Reference: Ballet Rehearsal Room – Access Report
Development Application

**BALLET REHEARSAL ROOM
SYDNEY OPERA HOUSE**

ACCESS REPORT DEVELOPMENT APPLICATION

Project: Sydney Opera House
Ballet Rehearsal Room
Document Type: Access Report – Development Application
Report Number: IAC-333

Figure 2 Accessible path of travel

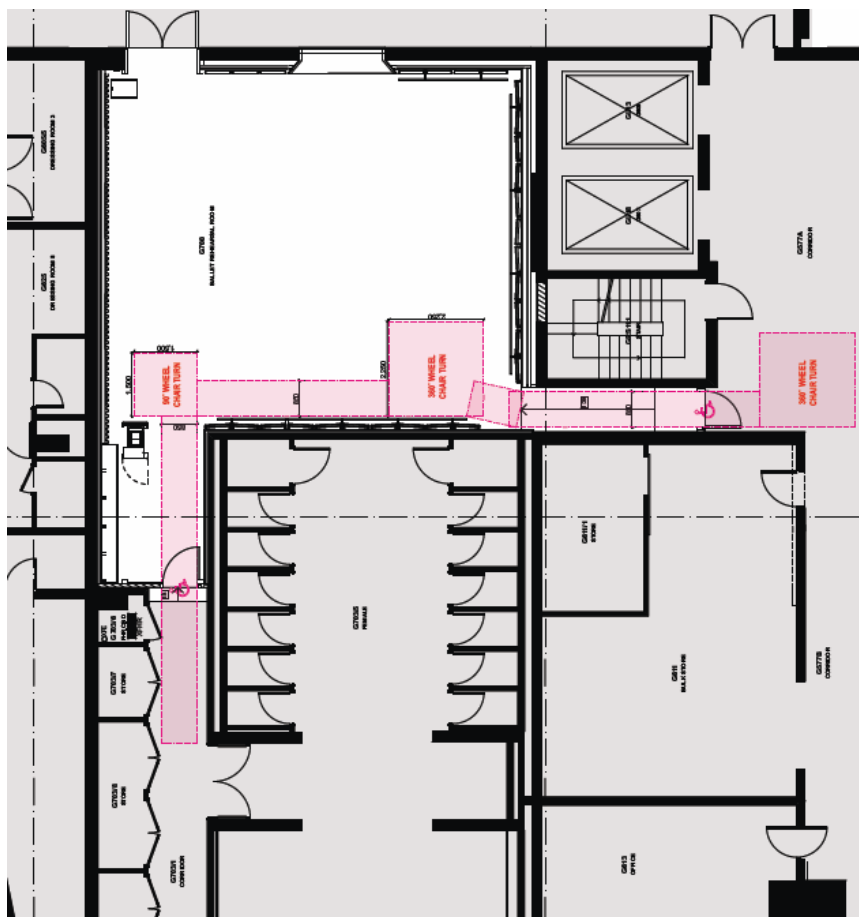
This access report relies on the Performance Solution prepared by iAccess Consultants addressing the use of a threshold ramp associated with Door GR-03. The detail of the threshold ramp relies on the provisions for threshold ramps noted in AS1428.1:2001 in lieu of AS1428.1:2009. The main difference between the differing versions of the Australian Standard relate to the maximum height permitted by the 1:18 threshold ramp. The substantiation for the reliance on the AS1428.1:2001 provisions relate to the acceptable reach range provisions of Clause 22 of AS1428.2:1992.

The passage connecting the Ballet Rehearsal Room with the lift lobby (GL13 & 18) does not provide the latchside clearances required by Clause 13 of AS1428.1:2009. To address this constraint, it is proposed to install a door assist device such as the DORMA PORTEO to Door GR-02. Push button switches will be provided within the Ballet Rehearsal Room and the lift lobby to operate door GR-02. A similar approach is adopted elsewhere within the Opera House where required clearances are not available.

Figure 4 Ballet Rehearsal Room – Path of travel

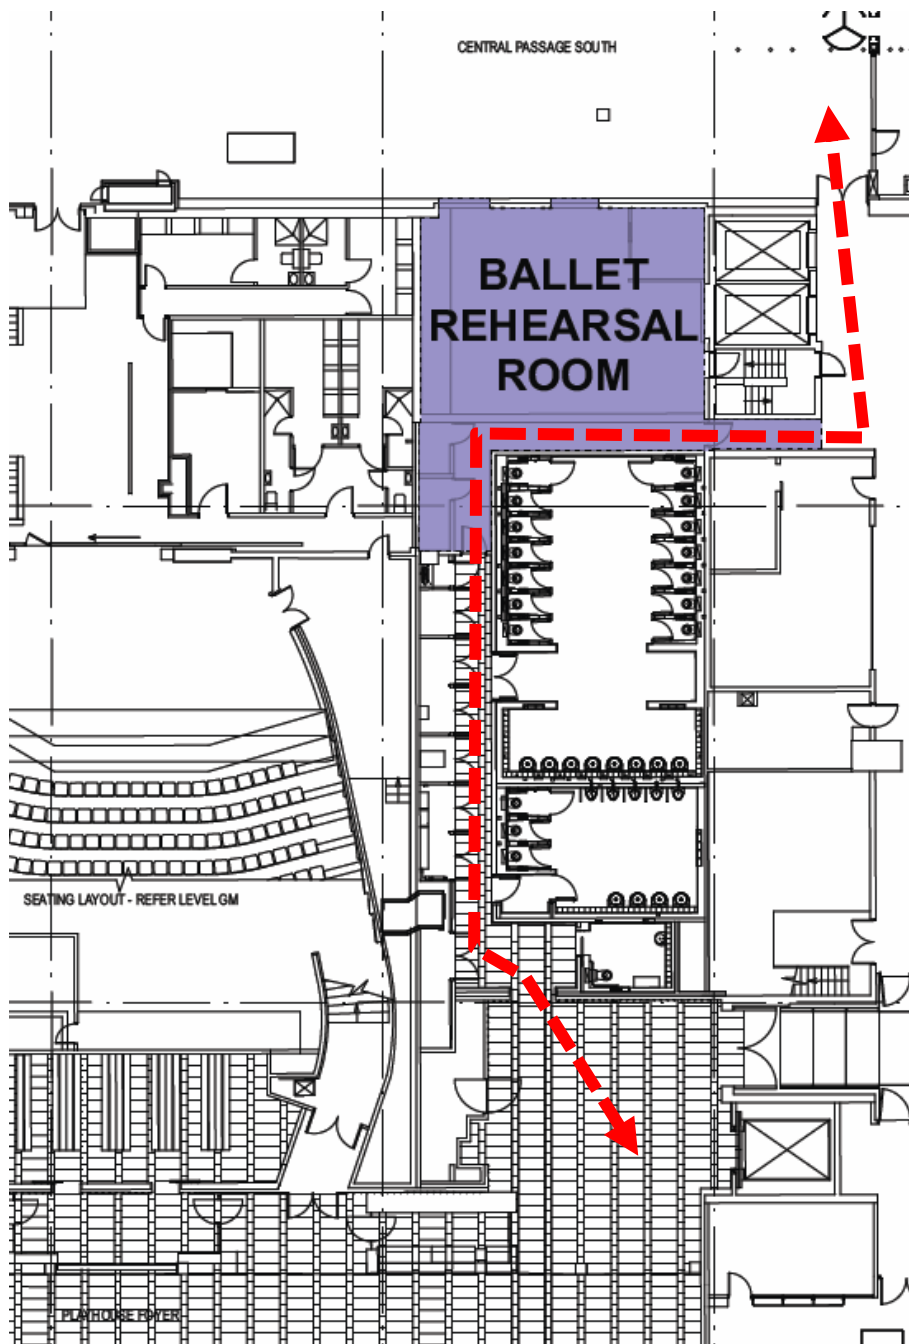
A door assist device is proposed to be installed to door GR-02 where reduced latchside clearances exits due to structural constraints.

A threshold ramp compliant to the provisions of AS1428.1:2001 is associated with door GR-03. A Performance Solution has been prepared to address the use of this form of threshold ramp.

Figure 5 Ballet Rehearsal Room – WC Facilities

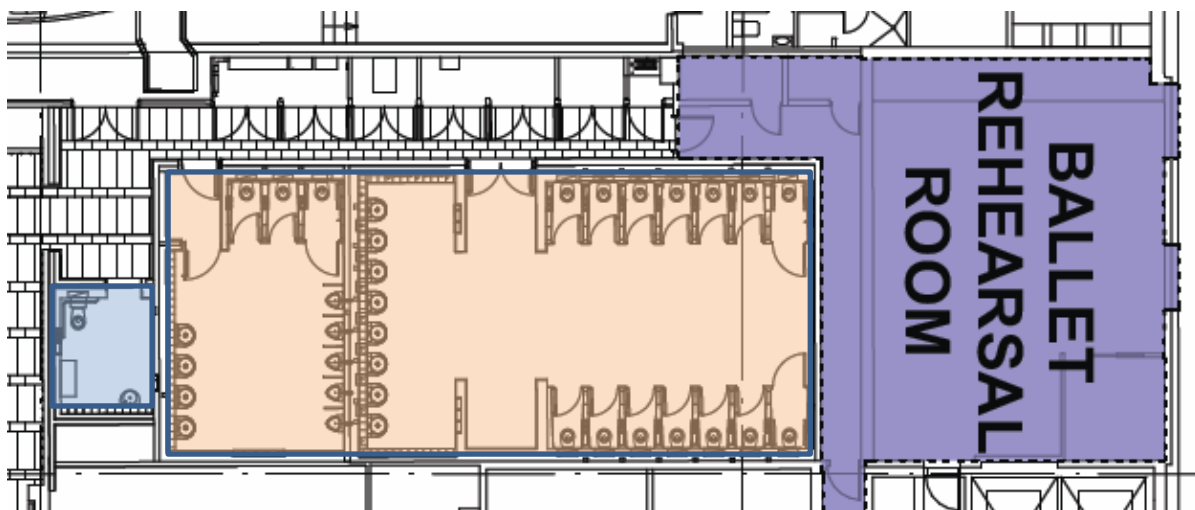
Existing male, female and unisex accessible WC facilities are located to the west of the Ballet Rehearsal Room located off the passage connecting to the Western Foyer. These are public WC facilities. The proposed Ballet Rehearsal Room works do not impact on the function of these existing WC facilities.

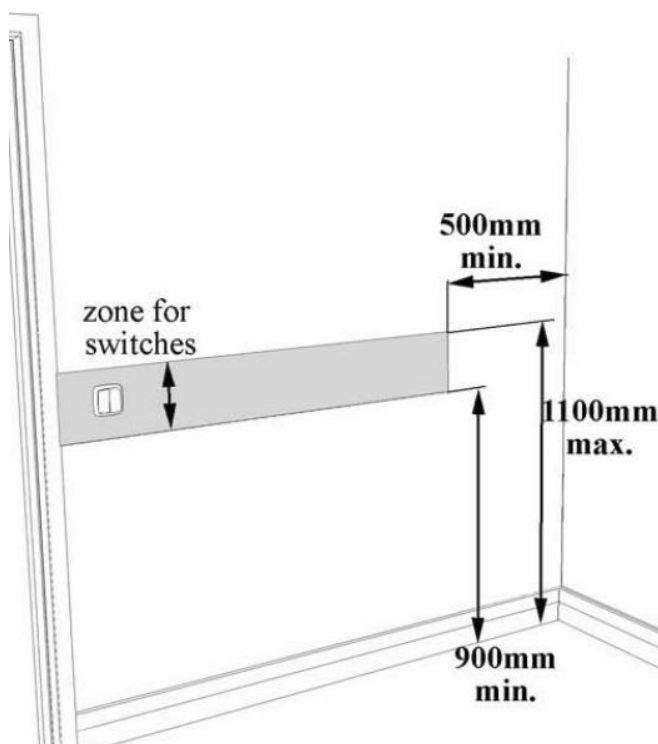
Any light switches, door release buttons or access control switches will need to be installed between 900-1100mm AFFL and not closer than 500mm to an internal corner.
